**SUBDIVISION &
ZONING AMENDMENT STAFF REPORT****Date: May 6, 2021****APPLICANT NAME**

Beaver Creek Subdivision

Subdivision Approval to create eight lots of record from one metes-and-bounds parcel and a portion of existing right-of-way; and Rezoning from R-1, Single-Family Residential District to I-1, Light Industry District (proposed Lot 8 only). **It should be noted, however, that any use permitted in the proposed district would be allowed at this location if the zoning is changed. Furthermore, the Planning Commission may consider zoning classifications other than that sought by the applicant for this property.**

SITE PLAN

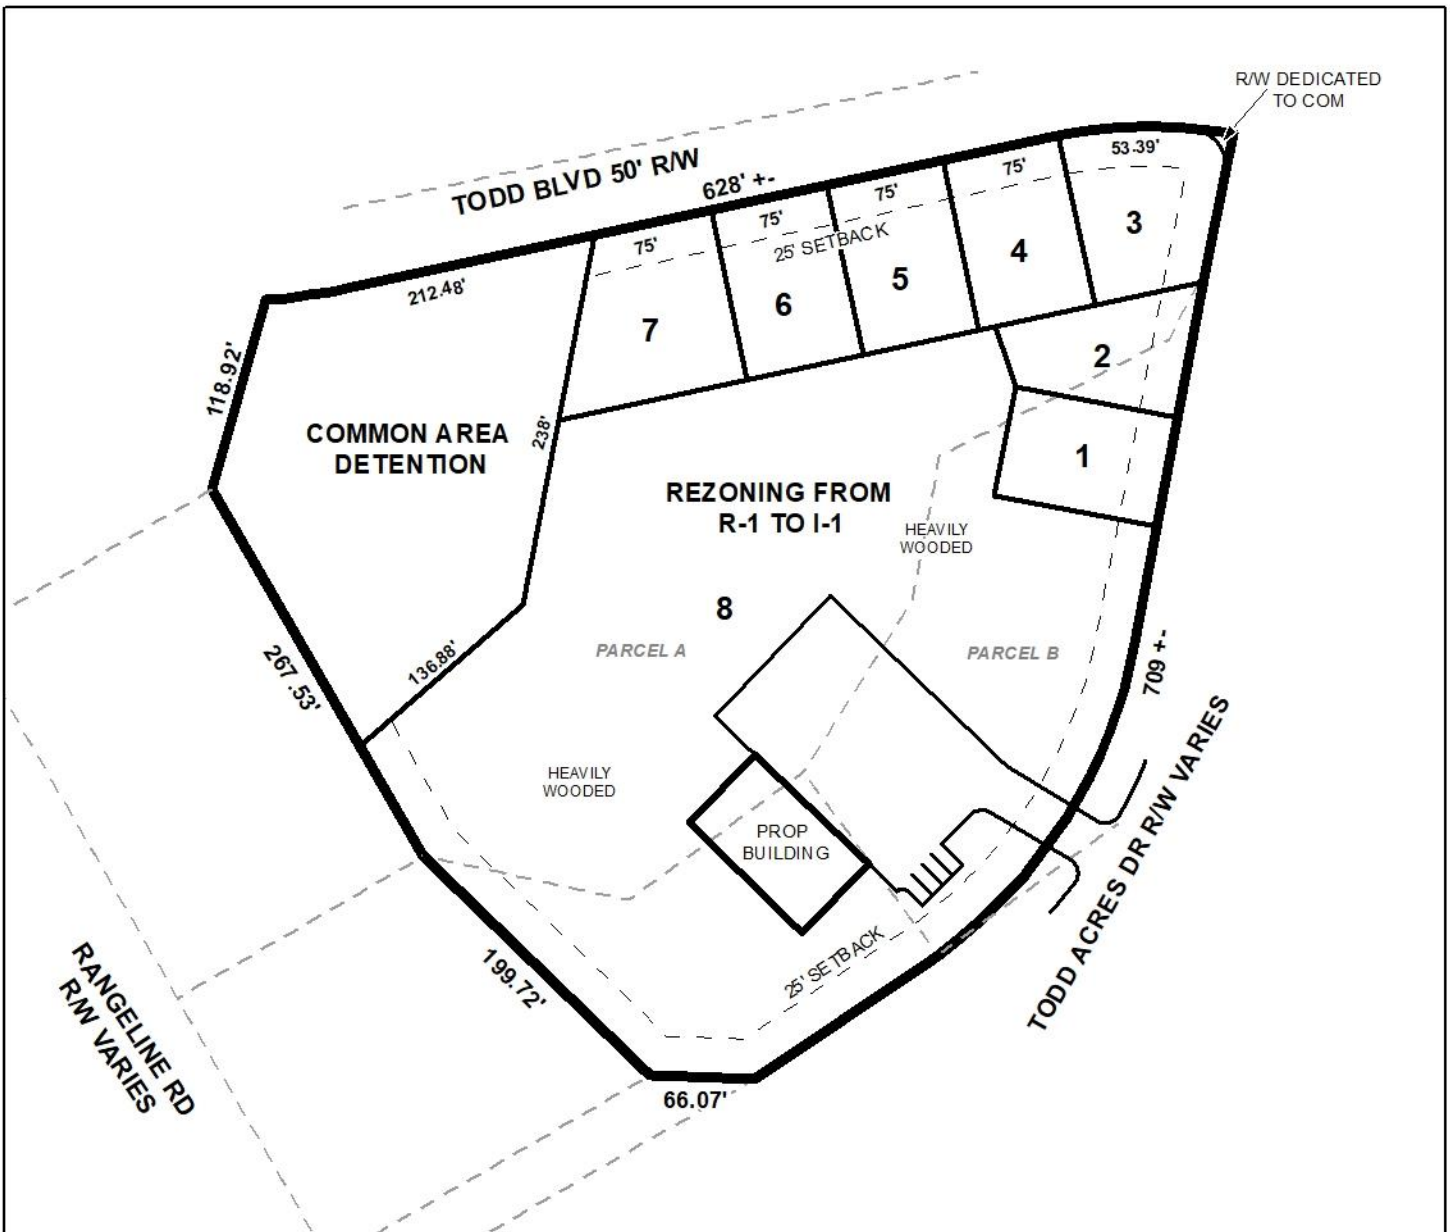
The applicant is proposing to construct a 6,000 square foot shop where engine work and maintenance would be performed on 18-wheelers and trailers. As no office space is proposed, and there are only two employees proposed to work on-site, only one parking space is required; the site plan illustrates four parking spaces.

The site plan does not specifically state what the proposed material for the parking and maneuvering area will be, but it should be noted that all required parking and maneuvering areas in an I-1 district are required to be paved with asphalt or concrete. However, if the applicant chose to have an area for 18-wheelers to be stored while they are waiting repair or pickup, there could be an aggregate area for that purpose.

A note on the site plan states that curb-side pickup will be utilized in lieu of a dumpster. If approved, this be retained on the site plan.
